**City of Lewisville, TX**  
**Agenda**  
**Joint Meeting of the Planning and Zoning Commission**  
**and Overlay District Board**

**TO:** Planning and Zoning Commission  
**FROM:** June Sin, Planner  
**DATE:** May 19, 2020  
**SUBJECT:** **Regular Hearing: Final Plat of Castle Hills Golf Course Addition Lots 6R-1, 6R-2, 6R-3 & 7, Block A; on 17.179 Acres out of the J. Dooley Survey, Abstract Number 343; With Estate Townhouse Residential (ETH) District and Single-Family Residential (R-12) District Zoning Designations; Located on the South Side of King Arthur Boulevard, Approximately 300 Feet West of Queen Peggy Lane, Being a Replat of Castle Hills Golf Course Addition Lots 6 and 7, Block A.**

# CH Golf Course FPCP\_Markup Summary

**TO:** Planning and Zoning Commission  
**FROM:** June Sin, Planner  
**DATE:** May 19, 2020  
**SUBJECT:** **Regular Hearing: Final Plat of Peck V.R. Addition Lot 7A, Block B; on 3.946 Acres out of the J.W. King Survey, Abstract Number 696; Zoned Light Industrial (LI) District; Located on the South side of South Valley Ridge Boulevard Approximately 320 Feet East of Kealy Avenue, Being a Replat of Peck V.R. Addition Lots 7&8, Block A.**

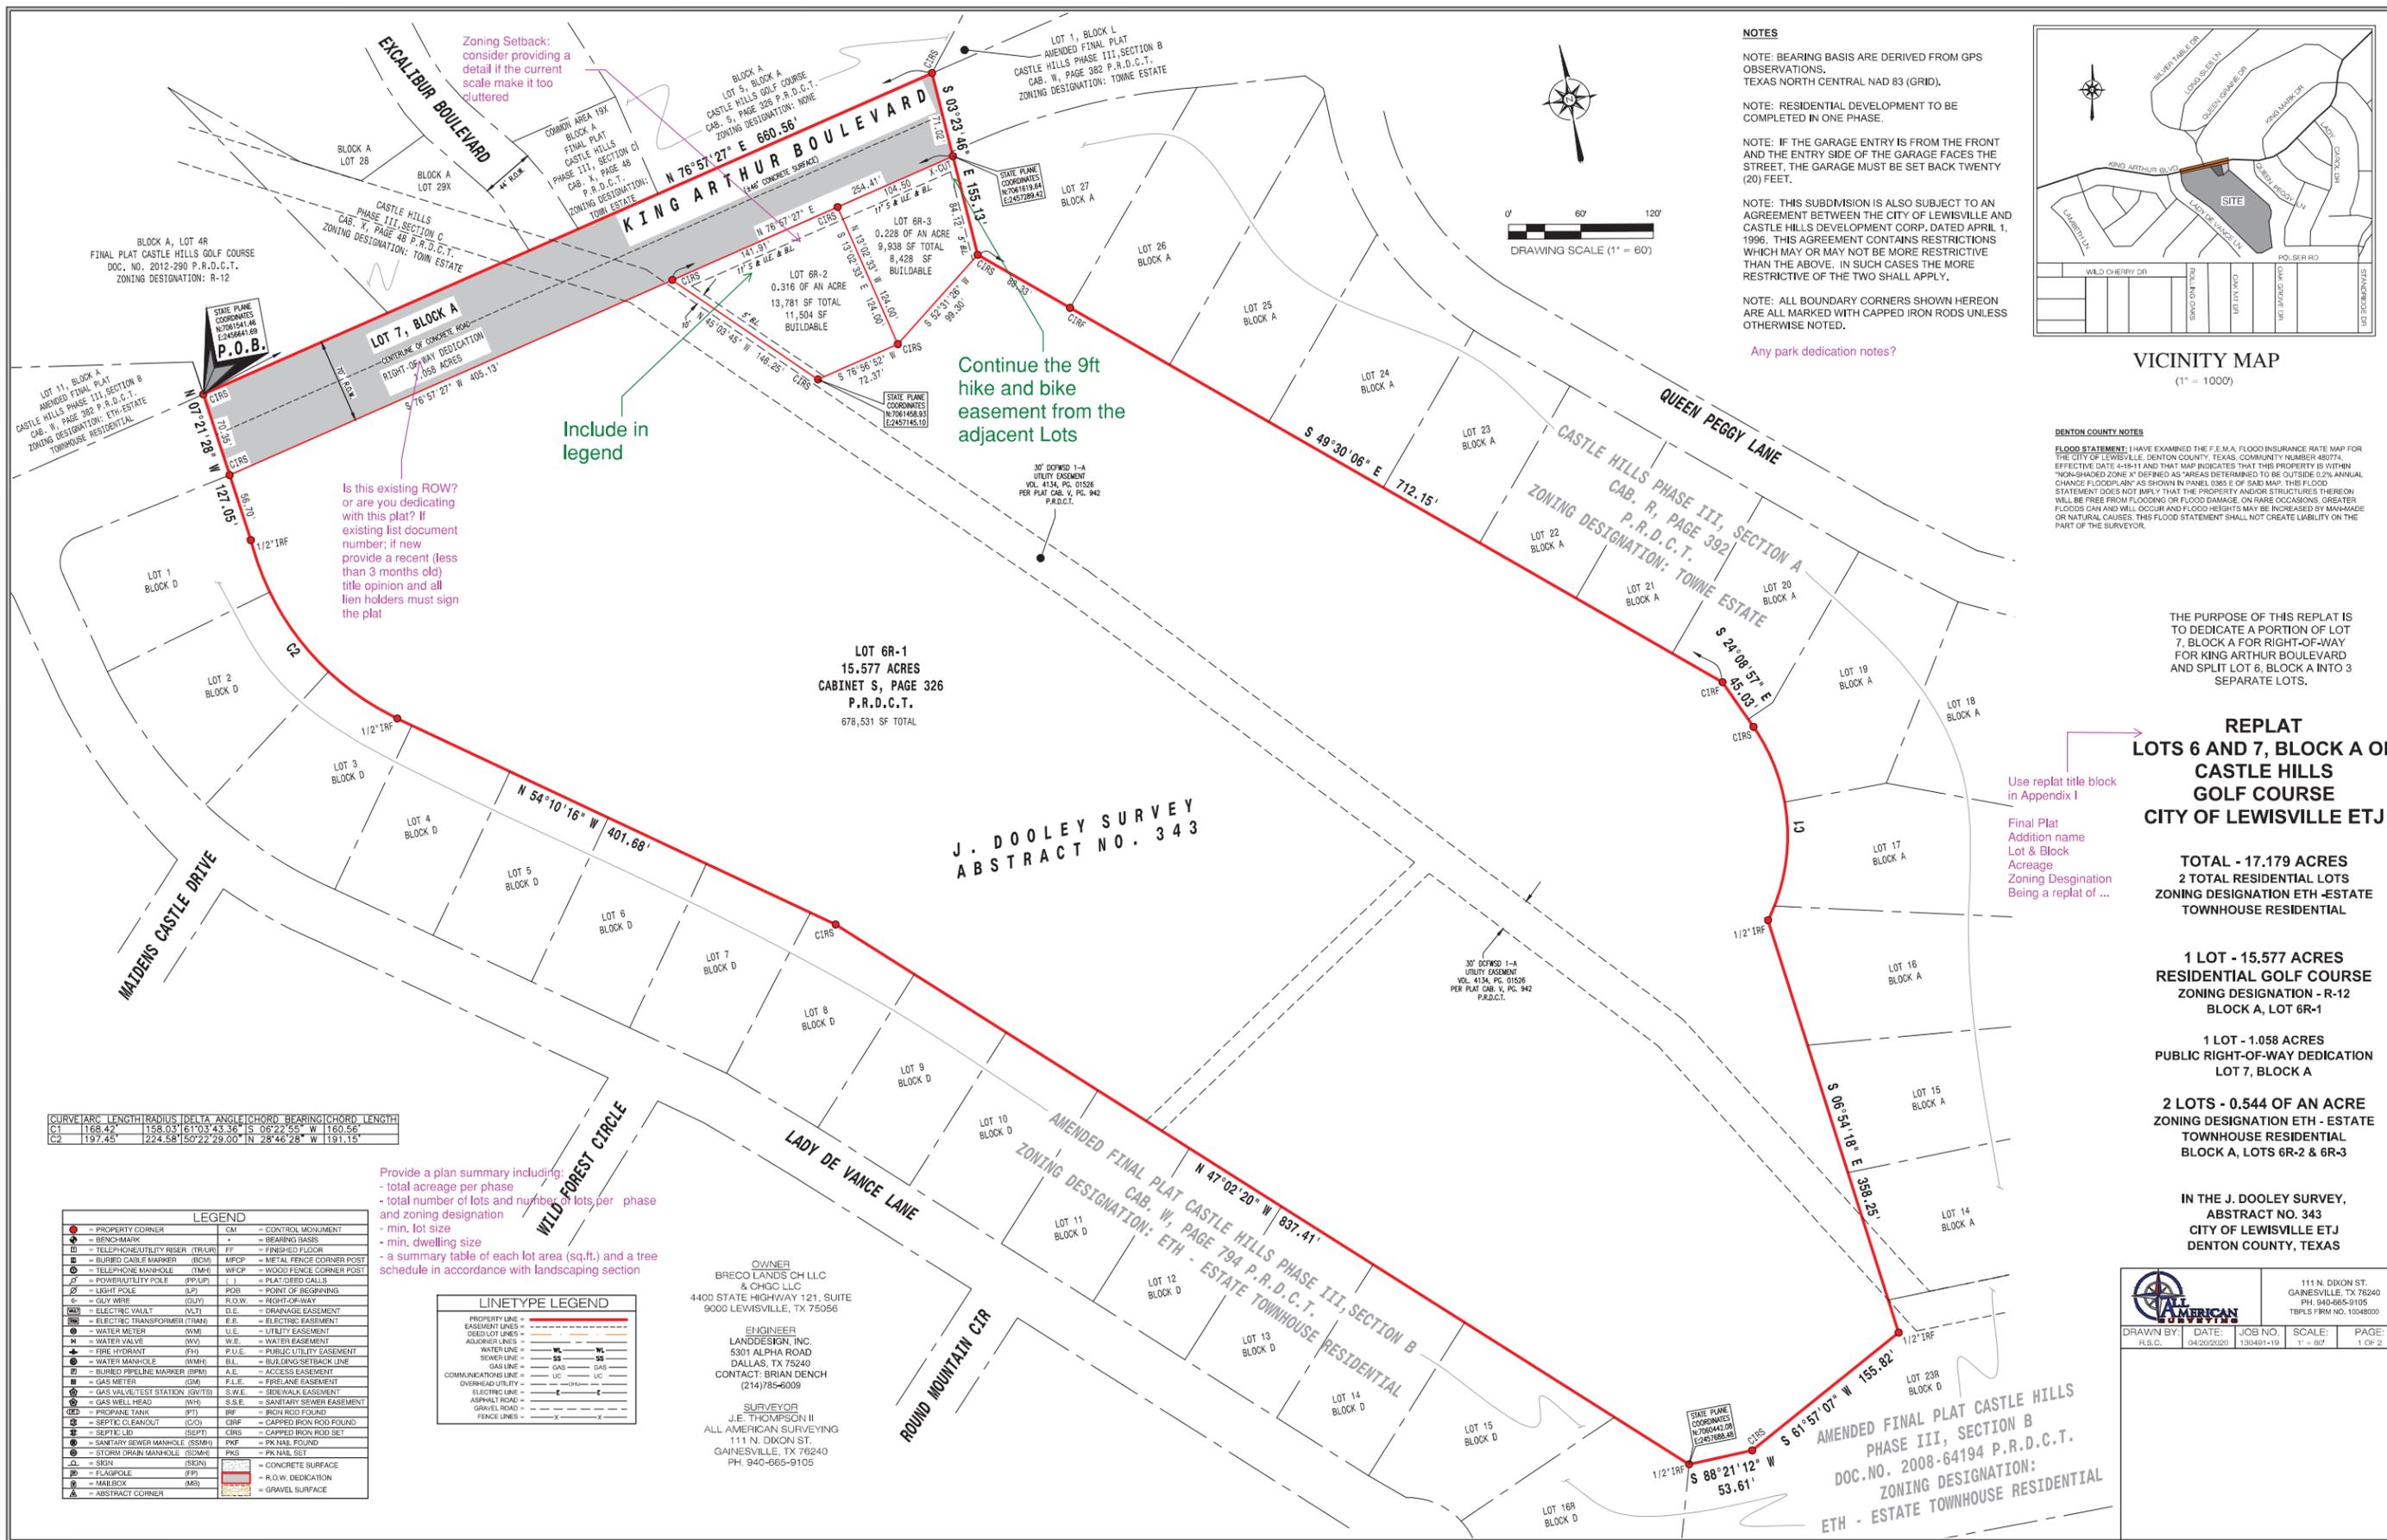
Show adjacent easements

Sheet size should be 22"x34" (providing extra margins for County Filing is okay. County requires 24"x36")

Any park dedication notes?

Zoning Setback: consider providing a detail if the current scale make it too cluttered

Continue the 9ft hike and bike easement from the adjacent Lots

Is this existing ROW? or are you dedicating with this plat? If existing list document number; if new provide a recent (less than 3 months old) title opinion and all lien holders must sign the plat

Use replat title block in Appendix I  
Final Plat Addition name Lot & Block Acreage Zoning Designation Being a replat of ...

Provide a plan summary including:  
- total acreage per phase  
- total number of lots and number of lots per phase and zoning designation  
- min. lot size  
- min. dwelling size  
- a summary table of each lot area (sq.ft.) and a tree schedule in accordance with landscaping section

Text Overlapping
Use correct City Secretary Signature block and PZ block per Appendix I

Use correct Title block per Appendix I for replat

SHEET 1 OF 1  
FINAL PLAT

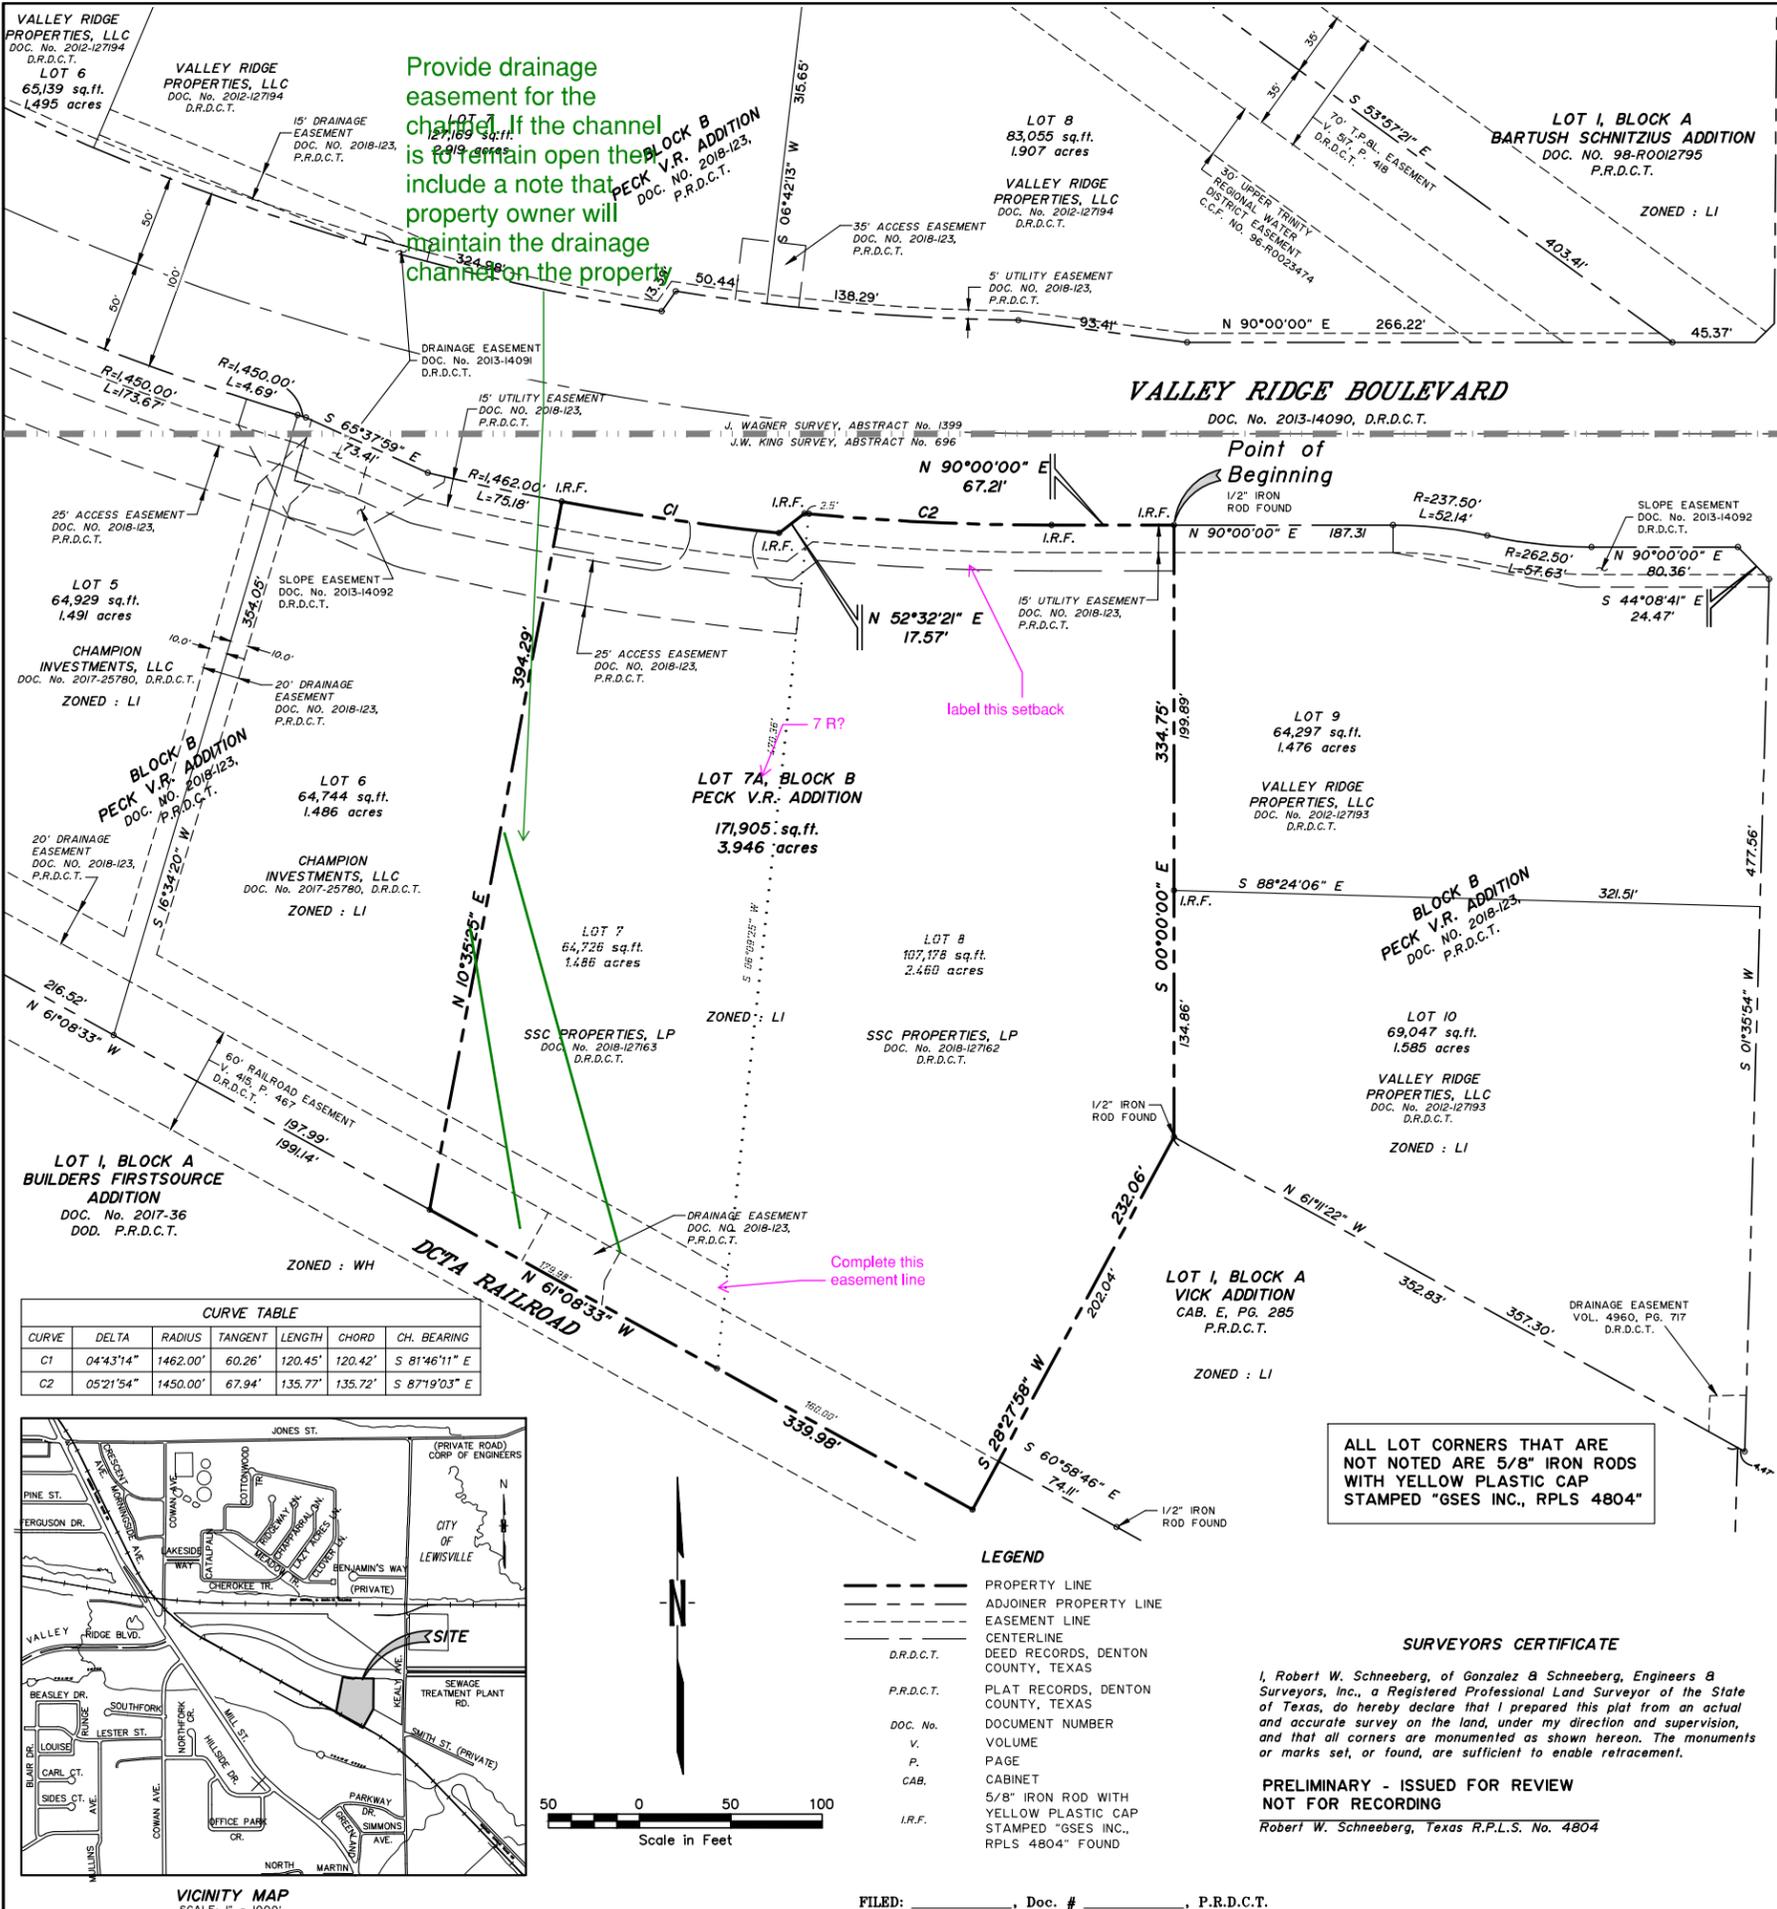
Provide drainage easement for the channel. If the channel is to remain open then include a note that property owner will maintain the drainage channel on the property.

label this setback

Complete this easement line

Add a note regarding park fees - is it paid at the time of building permit? or was it paid with last plat?

Is the lot really 7 A? Typically A & B are used is lots are subdivided. Is it typo for 7R?
